# UNITED STATES PATENT AND TRADEMARK OFFICE

APPLICATION NO.	FILING DATE	FIRST NAMED INVENTOR	ATTORNEY DOCKET NO.	CONFIRMATION NO.
10/799,115	03/11/2004	Brian J. Brozell	18209 USA	8232
27081	7590	04/21/2008		
OWENS-ILLINOIS, INC. ONE MICHAEL OWENS WAY, THREE O-I PLAZA PERRYSBURG, OH 43551-2999			EXAMINER SMALLEY, JAMES N	
			ART UNIT	PAPER NUMBER
			3781	
			MAIL DATE	DELIVERY MODE
			04/21/2008	PAPER

### Office Action Summary

## DETAILED ACTION

Shah US 4,375,885, Figure 8

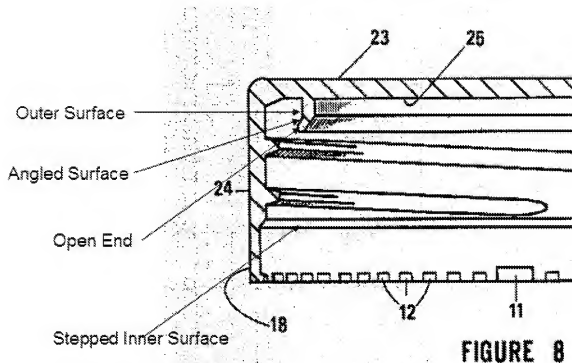
Shah '858, as modified, furthermore teaches the annular wall being reverse angled from said base wall and terminates in an open end (**Examiner notes in view of the rejection made above under 35 U.S.C. 112, 2<sup>nd</sup> paragraph regarding this claim and to the best degree the Examiner understands the claimed invention, the annular wall of Shah '858 is as "reverse angled" from the base wall as that of the instant invention.**), wherein said annular wall includes an outer surface and an angled surface, (**See diagram provided below.**) between said outer surface and said open end, wherein said open mouth is at least partially defined by an angled surface that cooperates with said angled surface of said annular wall of said closure to produce a spring force that tends to separate said closure from said container, wherein said closure skirt includes a first portion with an internal surface (**Read to be the inner surface of skirt 24.**) on which said at least one continuous internal thread is disposed, and a second portion having an internal surface stepped radially outwardly from said internal surface of said first portion and on which said at least one locking lug and said at least one stop lug are disposed (**Examiner notes Shah '858, figure 8, whereby the step is clearly shown in Figure 8, as noted in the diagram provided below.**).
